ASSESSMENT REPORT

Woolooware Bay Town Centre Concept Plan approval (MP10_0229 MOD 6) & Project Approval (MP10_0230 MOD 3)

Figure 4 – Level 1 (Proposed) (Source: Proponent's modification application, 2016).

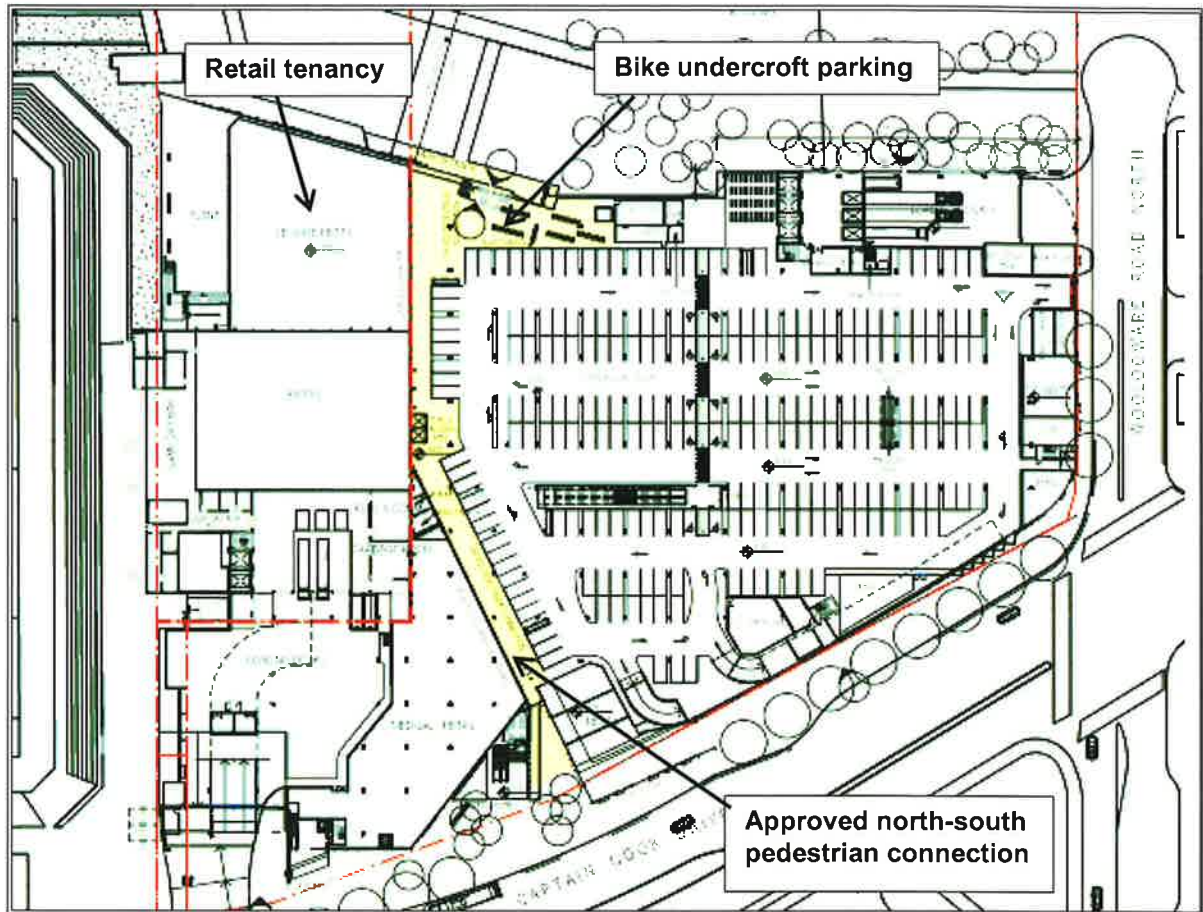
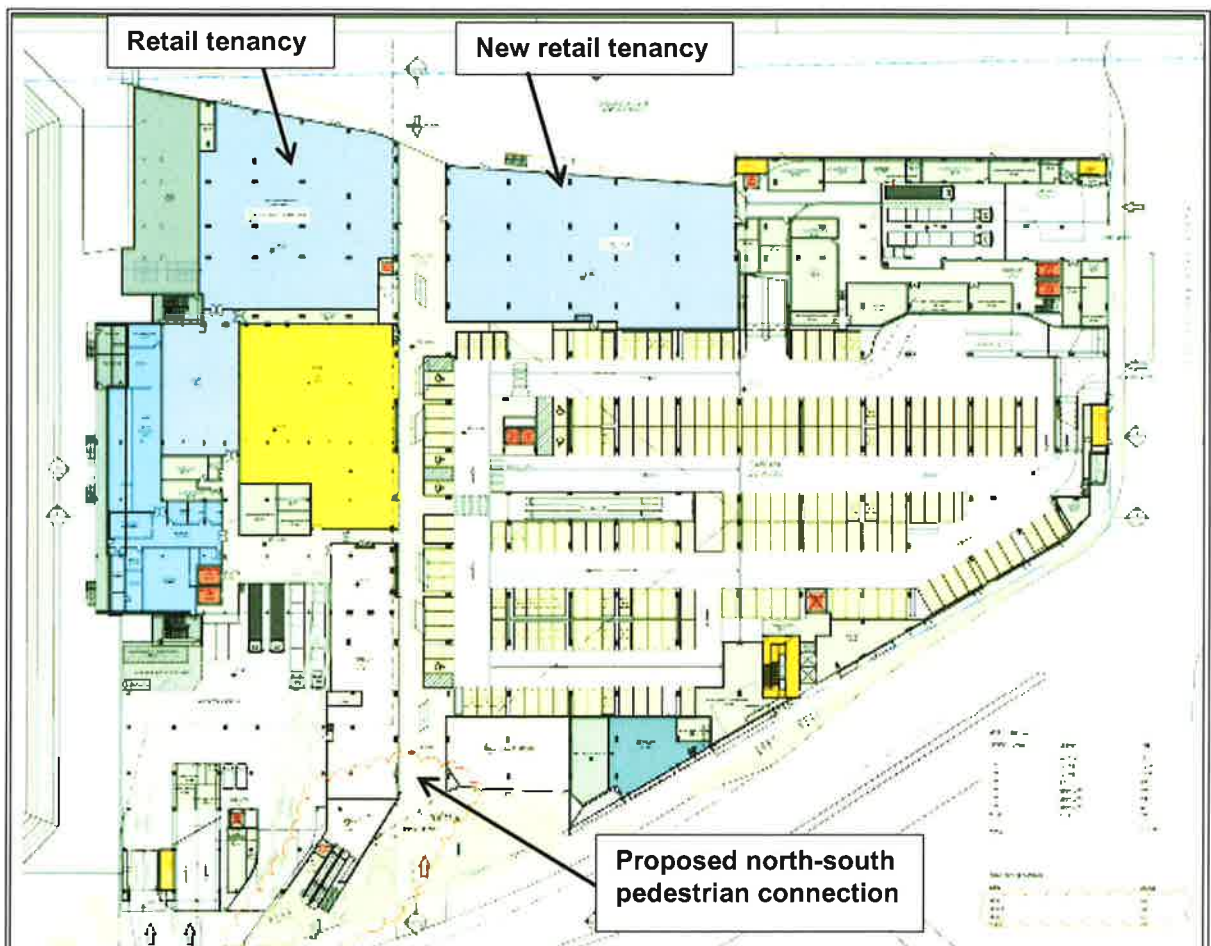
In relation to the Woollooware Bay frontage, Council raised concern with the poor activation associated with the service areas, liquor store and supermarket uses at ground level along the Woollooware Bay foreshore frontage of the site.

The Department notes the proposed modification includes additional retail tenancies at ground level fronting the foreshore compared to the approved development (refer to **Figures 3 and 4**). Subject to these retail tenancies providing a suitably glazed shopfront along the foreshore frontage, the Department is satisfied the proposed modification would result in improved building activation and surveillance along the Woollooware Bay foreshore frontage. Consistent with the approach taken for the other frontages in Condition C20 discussed in **Appendix C**, the Department has recommended a condition requiring 75 per cent of the shop fronts facing Woollooware Bay to be suitably glazed to maximise activation and amenity of this space.

Figure 11 – Southern elevation (Captain Cook Drive) – approved envelope shaded blue (Source: Proponent's modification application, 2016).

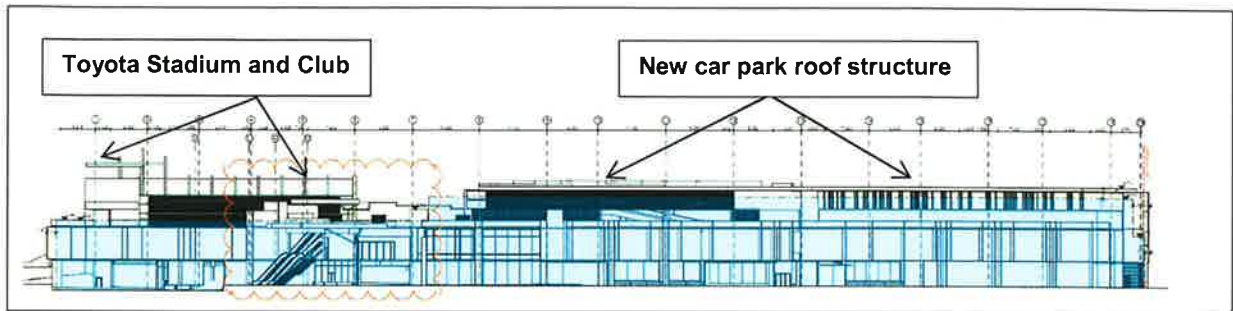
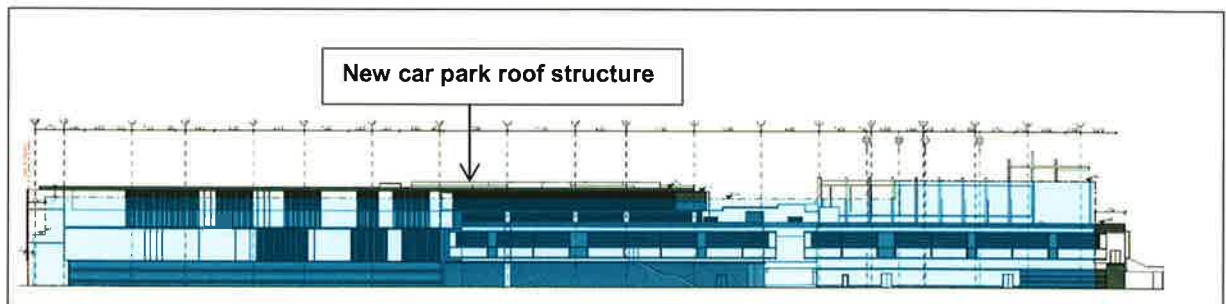
The proposal also seeks approval to extend the Level 4 car parking deck (within the approved building footprint) and provide a roof structure over the car parking area. This would increase the height of the approved building by 2.68 metres (from RL 18 AHD to RL 20.68 AHD).

The proposed car park roof extending above the approved building envelope is illustrated in **Figures 11 and 12**.

Despite the additional height the Department notes the Concept Plan approval already provides for a roof structure above part of the car park at RL 22.3 AHD. The proposed new roof would be located over a wider area, but would be 1.6 metres lower than the maximum building height allowed under the Concept Plan approval. The Department also notes the modified building height would continue to be below the 25 metre height limit applying to the site under clause 4.3 of the Sutherland Shire Local Environmental Plan 2015.

The Department considers the proposed roof structure would not significantly increase the height of the approved building or result in any adverse visual or amenity impacts to the surrounding area. The Department also considers the additional architectural and landscape detailing in the modified proposal (including additional glazing and a wider variety of facade materials) would improve the visual interface with the surrounding area compared to the original approval.

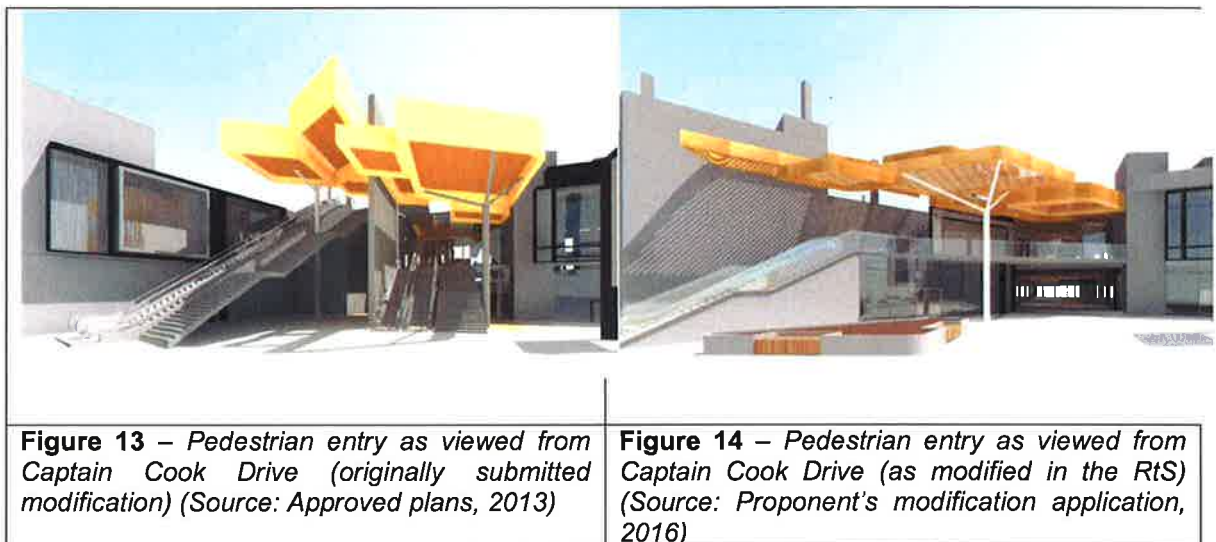
The key change to pedestrian access involves the straightening of the north-south pedestrian connection between Captain Cook Drive and the foreshore.

Council raised concern that the ground floor pedestrian entry and the north-south pedestrian connection to the foreshore was not clearly legible when viewed from Captain Cook Drive.

The Proponent subsequently amended the pedestrian forecourt entry by relocating the Level 2 retail stairs and Level 3 Club escalators to the western edge of the forecourt. The Department considers the amendments would make a significant improvement to the visibility and legibility of the pedestrian connection to the foreshore (refer to **Figures 13** and **14**).
